# Access Compliance Report Public Rights-of-Way (Curb Ramps)

| Main Street: MAYBECK_LN  |                                   | Cross Street: MAYBECK_LN |                        | Location:       | W  |
| ADA ID: RPRK211025114021 | Ramp Type: Type 1 - Perpendicular | Initial Pass/Fail: Fail  | Overall Compliance: No | Severity Score: | 45 |

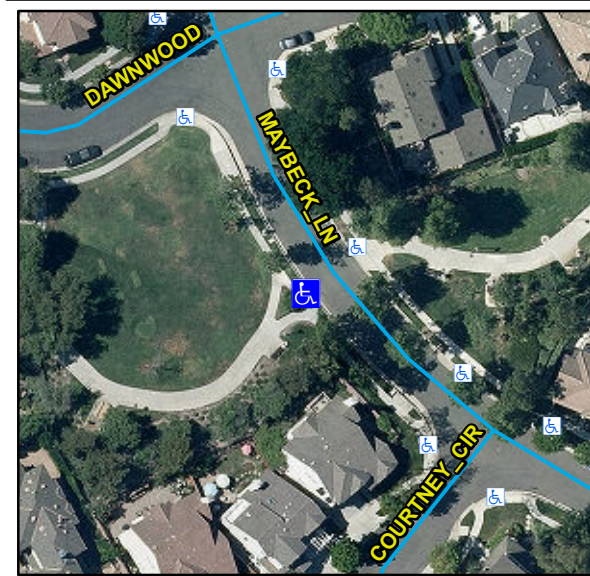
R204.3, R304.2.2, R304.5.3, STD 1115

| Compliance | Description                           | Data | Compliance | Description                   | Data |
|------------|---------------------------------------|------|------------|-------------------------------|------|
| No         | Ramp Run Slope (%)                    | 13.1 | N/A        | Flare Slope LT (%)            | N/A  |
| No         | Ramp Cross Slope (%)                  | 5.8  | N/A        | Flare Traversable LT          | N/A  |

Remove & Replace Entire Ramp.
